Sub.: VILLAGE SEWER REPAIRS

MEMORANDUM

FROM: Brett Hanke
Association Engineer
TO: Bill DeFer
SUBJECT: Recommendation
Construction Scope Trunk Sewer Repairs

RECOMMENDATION

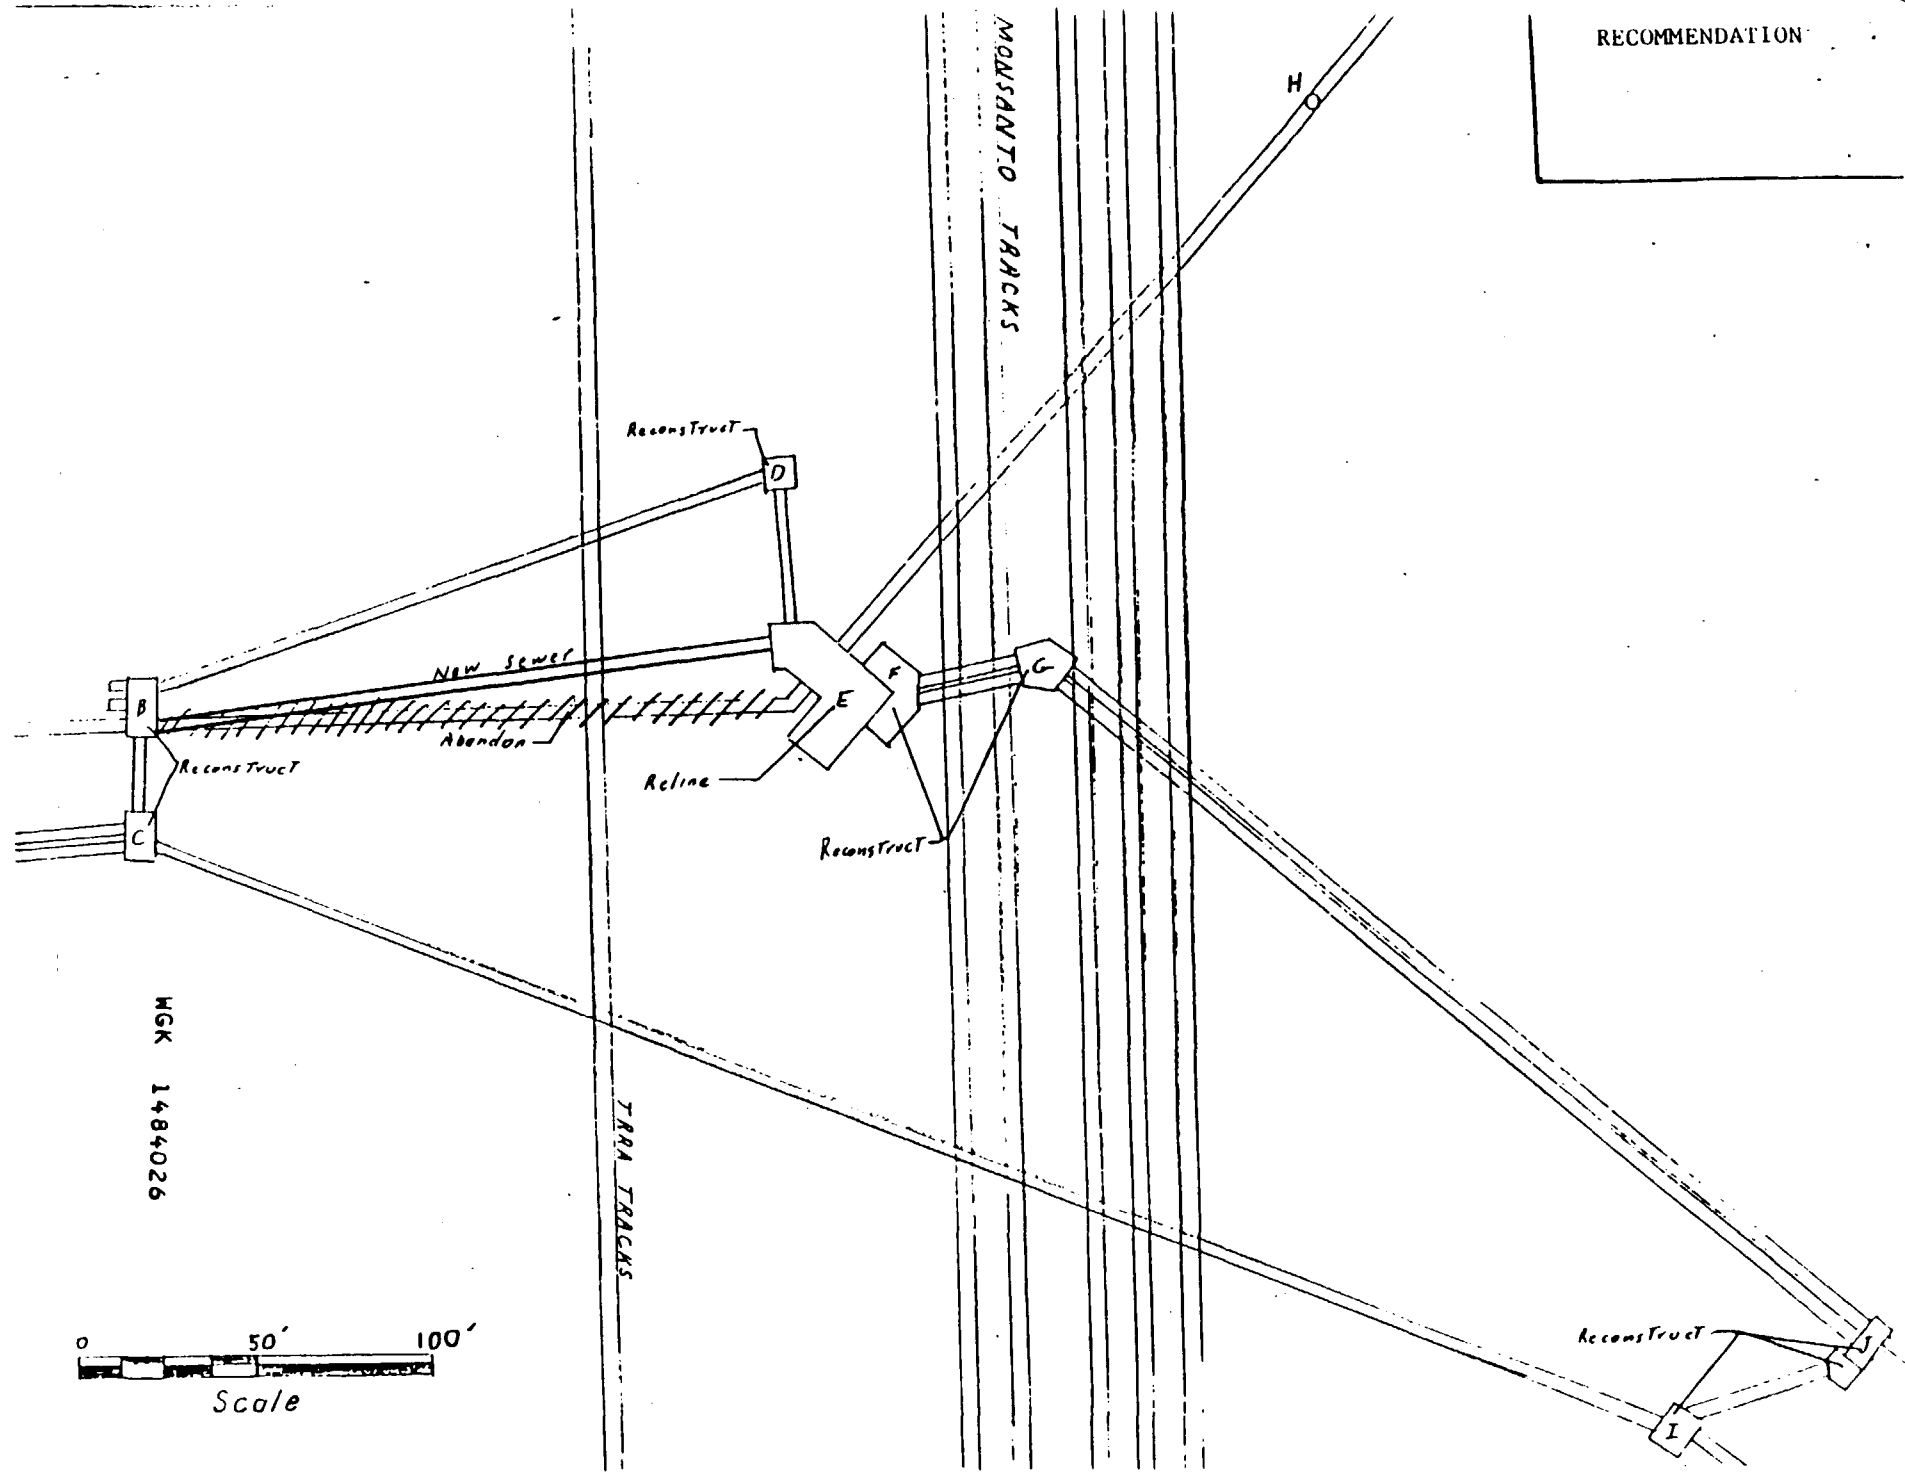
- ① Can Box For G be eliminated
- ② Assume box #1 design is acid brick lined
- ③ Cost is estimated at,?

a. Reconstruct deteriorated boxes B, C, D, F, G, and I. Reconstruction assures structural integrity and the employment of latest technology while modifying the box to extend fully open to the surface for ease of maintenance.

b. Repair Box E by crack grouting and patching lining. Cleaning of liner plate, tuckpointing, and patching of missing tiles should be a sufficient repair absent structural defects of the box walls or floor. An option would be cleaning and patching, then applying a membrane system over it and bricking a full new lining.

c. Construct new line under TRAA Tracks. (This line is now sunken and leaking. The new line should be supported on piles to preclude future settlement when reconstructed.)
